SERVICE BULLETIN

SERVICE BULLETIN INDEX

FIGURE 1

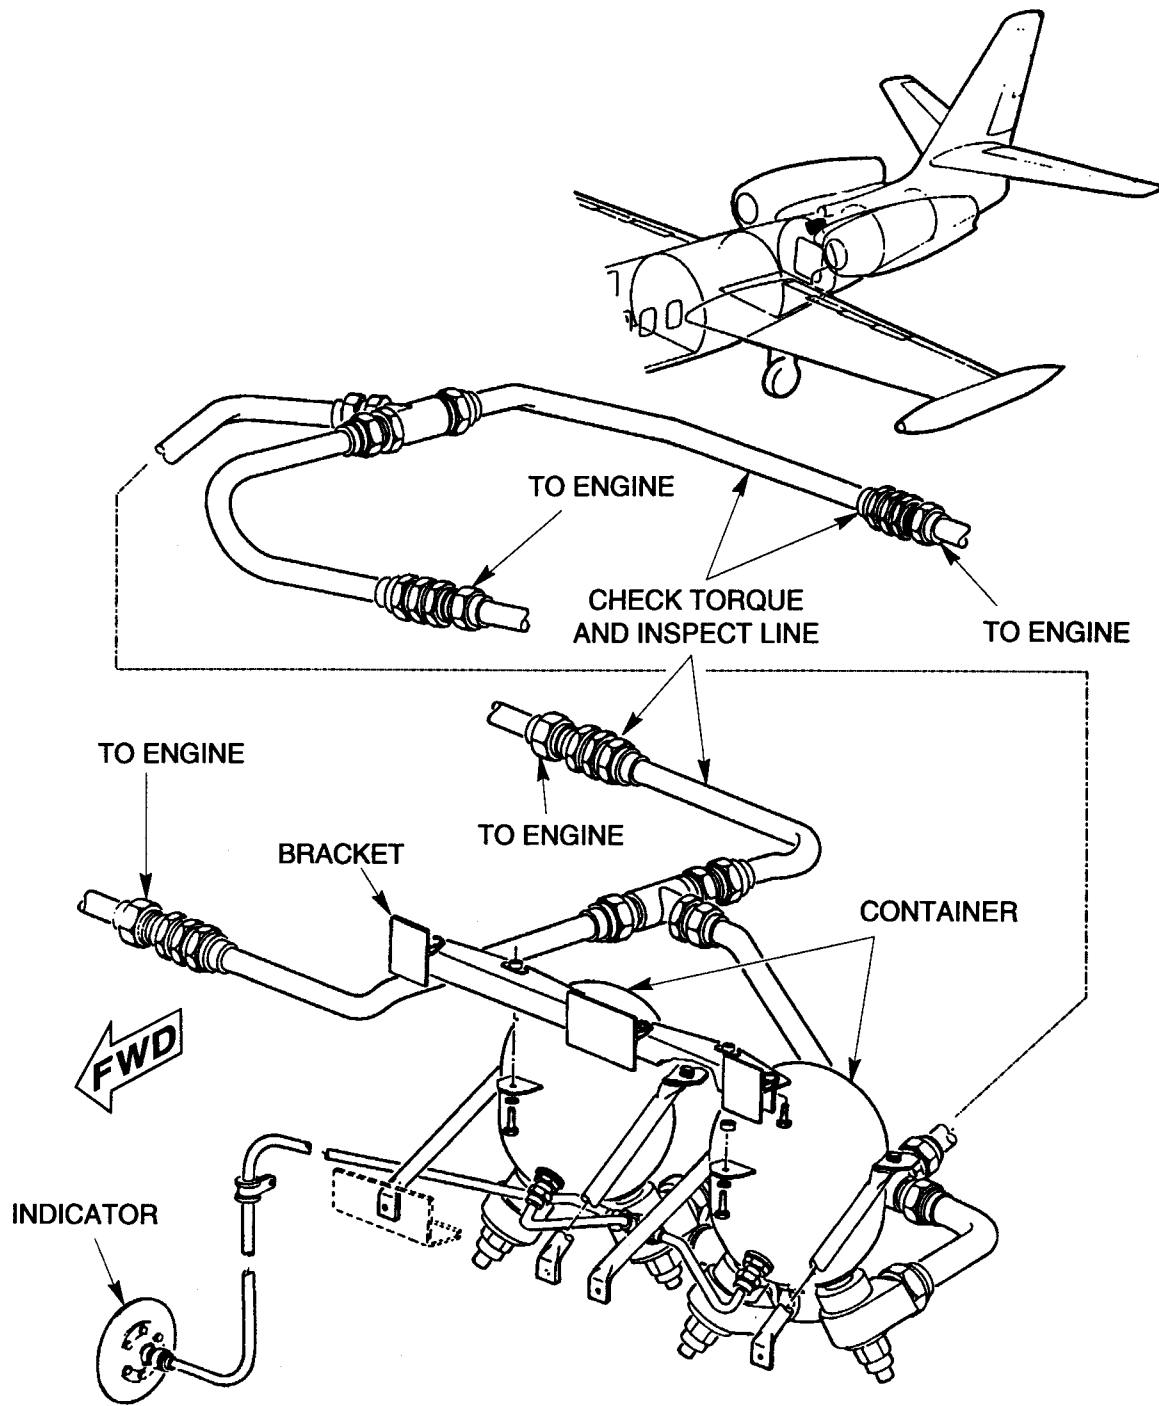
- (1) Gain access to fire extinguisher lines by removing forward wall from aft baggage area.
- (2) Using a flashlight and mirror inspect lines for signs of external damage. Refer to Figure 1.
- (3) Using a 7/8 inch crows foot, 24 inch extension and ratchet, verify lines are tight on bulkhead fittings.
- (4) Install panel.

- (1) Gain access to fire extinguisher lines by removing oval panels on firewall. Refer to Figure 2.
- (2) Inspect lines for any signs of external damage. Refer to Figure 1.
- (3) Using a 7/8 inch wrench, verify lines are tight on bulkhead fittings.
- (4) Install panel.

FIGURE 1
CUTTING OF RUDDER SERVO TRIM TAB
SHEET 1 of 2

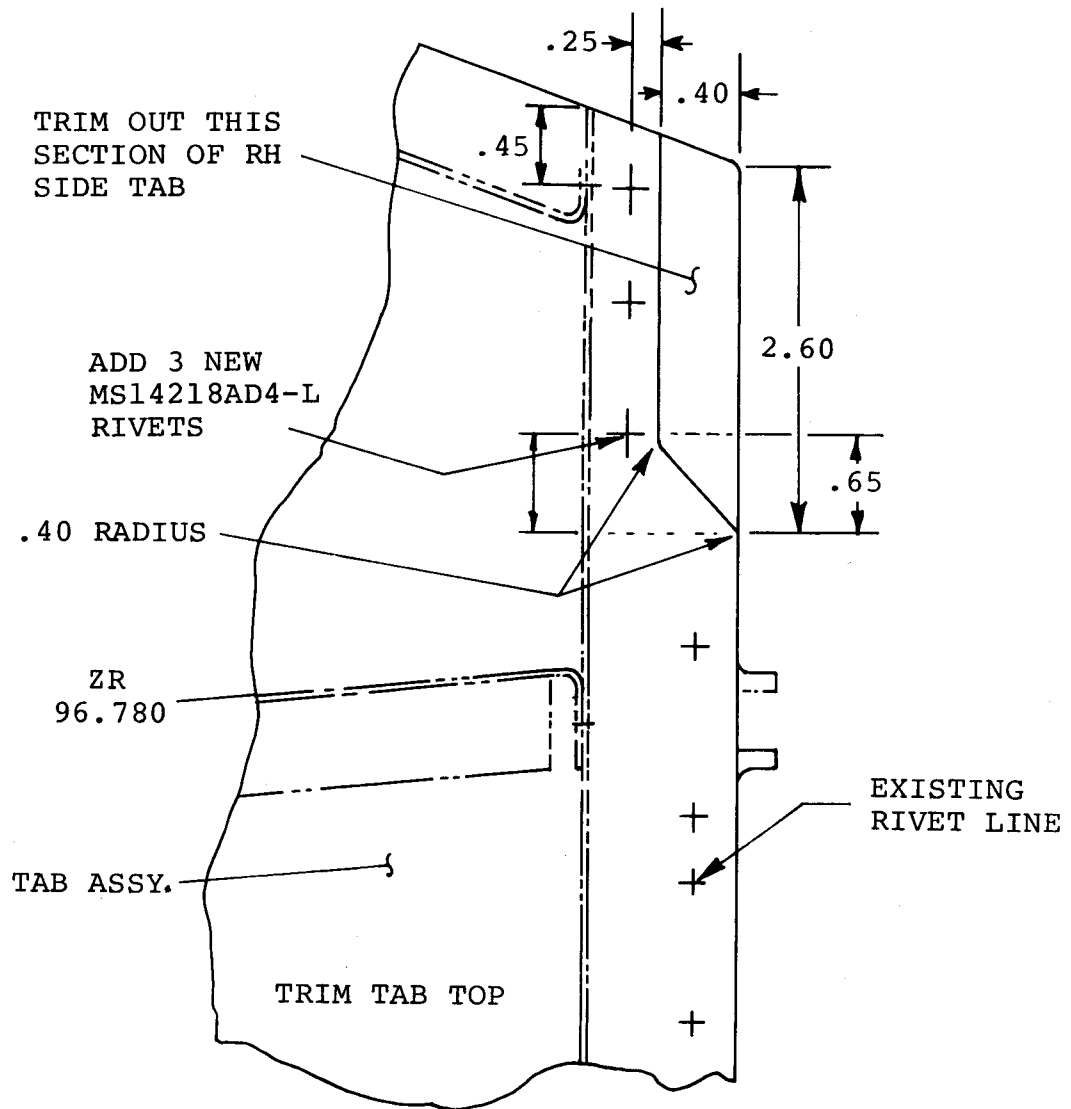
- A. Remove the rudder servo trim tab from the aircraft rudder in accordance with 1124/1124A Maintenance Manual, Chapter 27-20-00, removal/installation paragraph 3A.
- B. Layout area to be trimmed in accordance with Figure 1.
- C. (1) Before trimming off any material observe the proposed cutline for rivet edge distance to the spar radius and leading edge. If the edge distance on your rudder tab conforms to the measurements on Figure 1 utilize the rivet pattern reflected in Figure 1 to effect the modification.

Make sure that a minimum of 2D (.25) edge distance from center of rivet hole shall be maintained after cutting out completely the existing 1/8 rivet holes in a straight line as shown in Figure 1.

- (2) If the remaining edge distance results in less than those measurements reflected in Figure 1, go to Figure 2.
- (3) Since edge distance determines rivet size and quantity, it is important that the number of rivets in Figures 1 and 2 be used to maintain integrity of the tab leading edge. Select the rivet pattern that will best suit the required number to accomplish the modification.
